ITEM 3

Application Reference	DC/079812
Location:	Wyberslegh Hall Farm 25 Wybersley Road High Lane Stockport SK6 8HB
PROPOSAL:	Partial demolition, redevelopment and change of use of existing buildings to form four residential units with curtilage, including the provision of car parking and garaging, additional access and associated landscaping (Full Planning Application)
Type Of Application:	Full Application
Registration Date:	24/02/2021
Expiry Date:	21/04/2021
Case Officer:	Mark Burgess
Applicant:	J & C Wybersley Ltd
Agent:	Eden Planning

DELEGATION/COMMITTEE STATUS

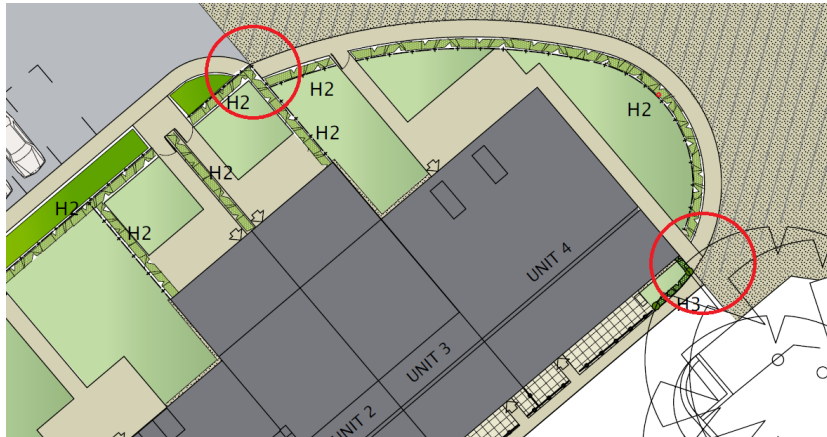
The development is proposed to be served via an existing access which serves the site. This, which would be improved as part of the scheme, would continue to serve Wybersley Hall and farm, as well as the proposed dwellings. In addition, a new access is proposed to be constructed to serve an existing paddock. The TS outlines that the proposed amended access will benefit from a level of visibility that accords with vehicle speeds. This would be achieved by building out the kerb line into the carriageway. Whilst I consider this acceptable, in principle, the TS does not include full details of the speed survey (including full results and details of exactly where the survey was carried out) and therefore it is not clear whether the speeds derived from the survey are correct. As such, I would ask that full details of the speed survey are requested to allow this to be checked.

In addition, whilst I note that the TS outlines that sufficient width will be retained to allow two-way working in the vicinity of the access, swept-path analysis has not been carried out to demonstrate that this would indeed be the case or that the geometry of the access would be suitable to allow vehicles to manoeuvre into and out of the site. I also note that a Stage 1 Road Safety Audit has not been carried out for the works to form the build-out (required for schemes that involve such highway works). Both are considered to be required to allow the scheme to be fully assessed and therefore I consider that there is a need for the application is deferred to allow these to be produced, submitted and reviewed.

With respect to the proposed access that would serve the existing paddock, although the TS outlines that this will also benefit from a level of visibility that accords with vehicle speeds, as with the main access, full details of the speed survey have not been submitted and noting that it appears that only a single speed survey has been carried out to determine vehicle speeds for both accesses, I would question whether the results from the speed survey are appropriate. As such, full details of the speed survey need to be submitted for review. In addition, vehicle swept-path tracking diagrams have not been submitted to demonstrate that vehicles would be able to negotiate the access and no details of the internal site layout have been submitted to show how the access will tie in with the internal site layout or that sufficient room will be available within the site for turning and manoeuvring. As such, I consider that there is also a need for the application to also be deferred to allow vehicle swept-path tracking diagrams and an internal site layout for the paddock to be produced, submitted and reviewed.

Regarding surfacing of the access, I note that a gravel surface is proposed. Such a surface is not suitable for some people with disabilities and can be problematic for prams / buggies, it can result in loose material being dragged onto the highway (which can be a hazard) and is generally not suitable for use where service vehicles will turn (as ruts can form). As such, I consider the surfacing material should be

reviewed. I also note that there are two locations in the site where footpaths do not tie up (as shown on the plan below). This issue also needs to be reviewed.

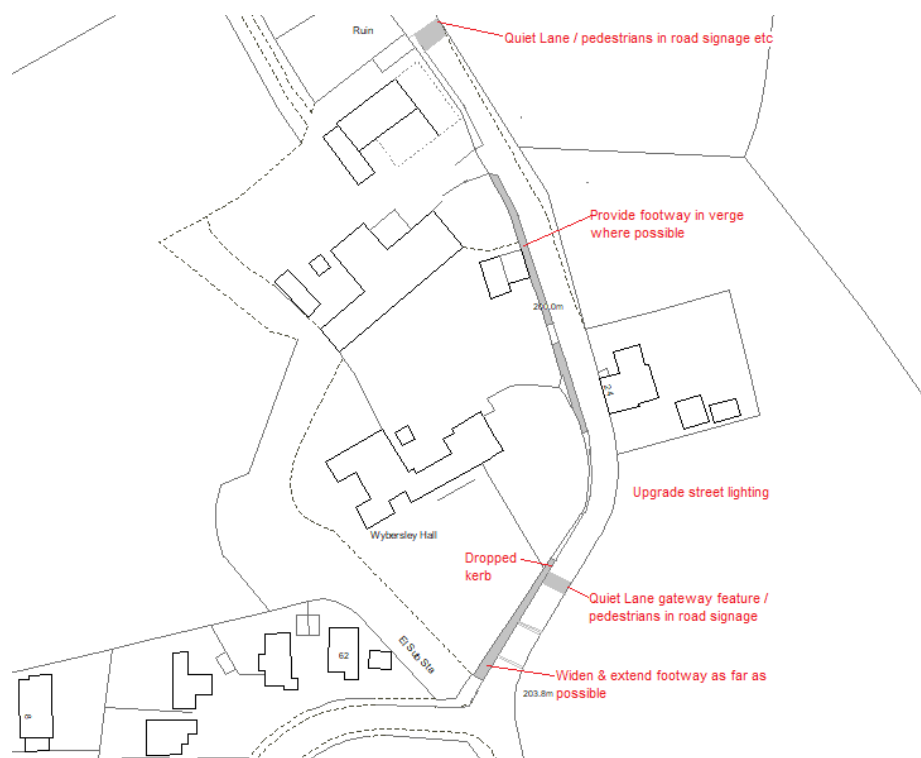
The site is located just beyond the edge of the High Lane settlement on a rural, single-track country lane. A detailed review of the site's accessibility concludes that:

- 1) The site lies approx. 800m from the nearest bus stop
- 2) The nearest bus stop is served by a single bus service (the 199)
- 3) The site lies approx. 2km from the nearest train station (Disley)
- 4) The site lies in excess of 1km from the nearest shops and approx. 3.5km from the nearest district shopping centre (Marple)
- 5) The site is not situated near any business parks, industrial estates or other employment areas
- 6) The site is situated on and, accessed via, a rural country lane which does not have footways or a full set of street lighting
- 7) There are no cycle facilities within the vicinity of the site and gradients in the vicinity of the site are conducive to walking / cycling
- 8) The site has low level of accessibility (Level 2) on the Greater Manchester Accessibility Levels (GMAL) model

As such, based on this analysis I would conclude that the site has a low level of accessibility. This is reflected by fact that census data indicates that 85% of people travel to work by car and the higher than average level of car ownership in the area.
